Appendix "D" - Recommended Second and Third Reading Alterations to the Precinct 'G' Secondary Plan (Revised)

Figure 4

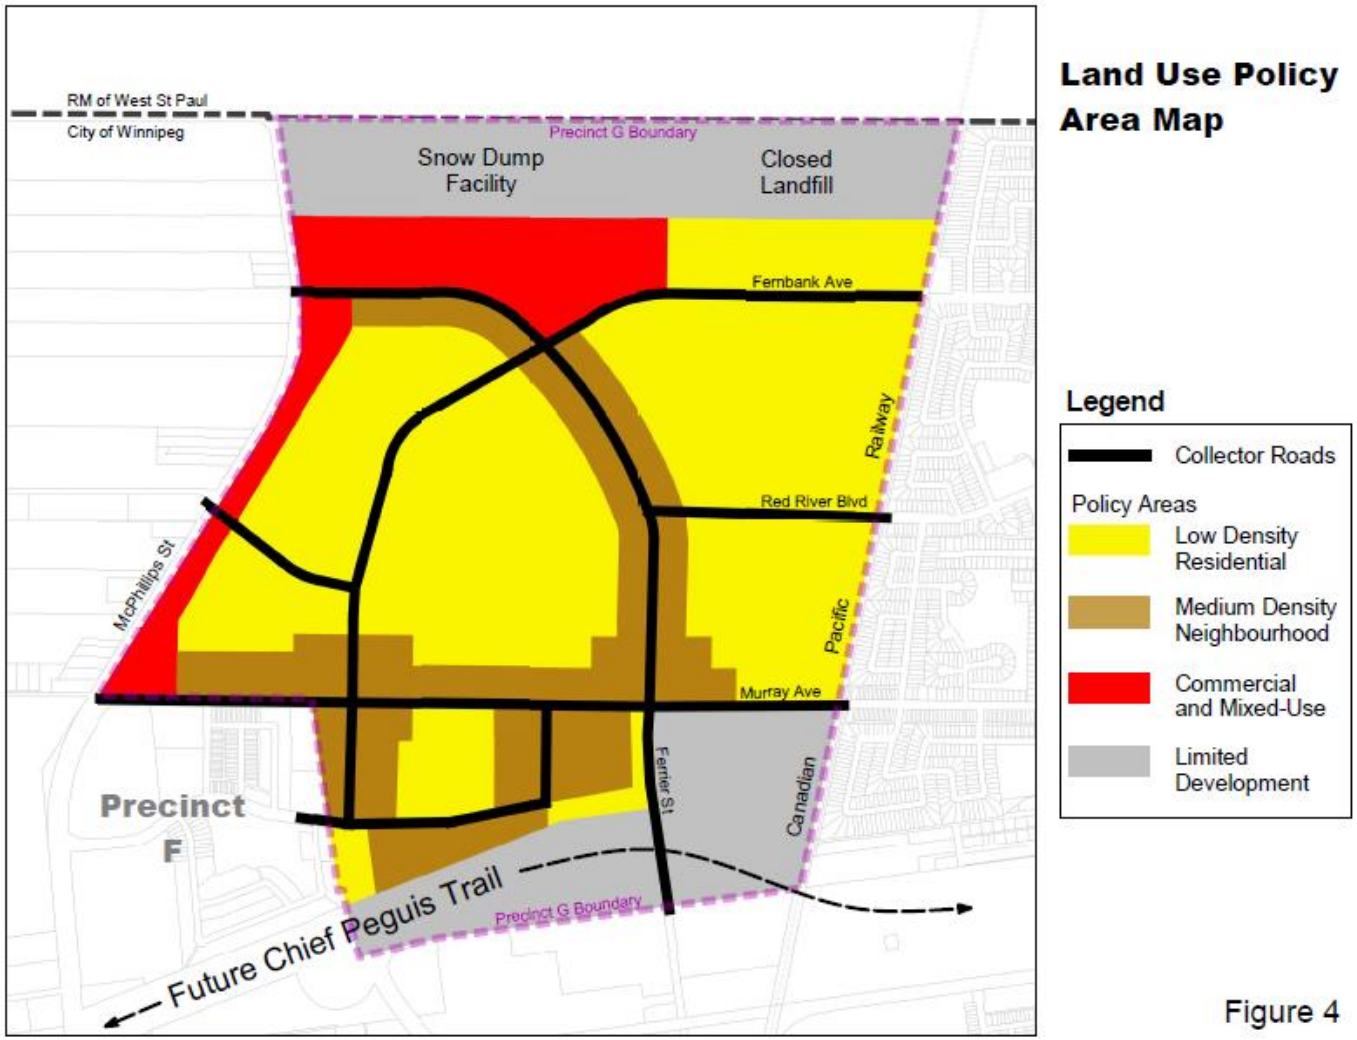
37	Delete *Figure 4 "Land Use Policy Area Map"* and replace with the following:

Figure 5

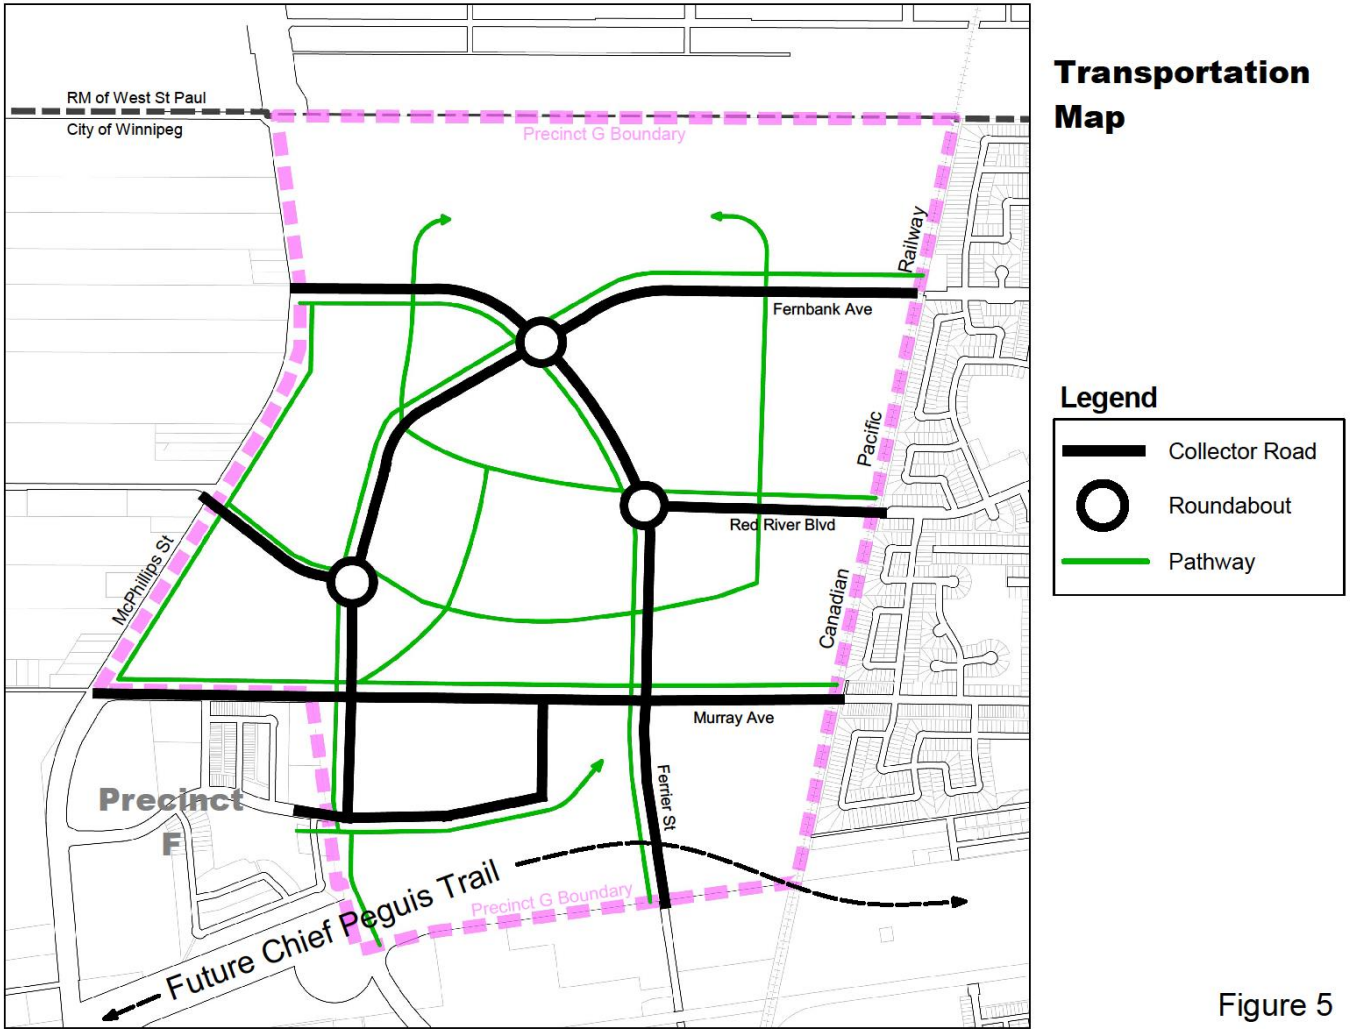
38	Delete *Figure 5 "Transportation Map"* and replace with the following:
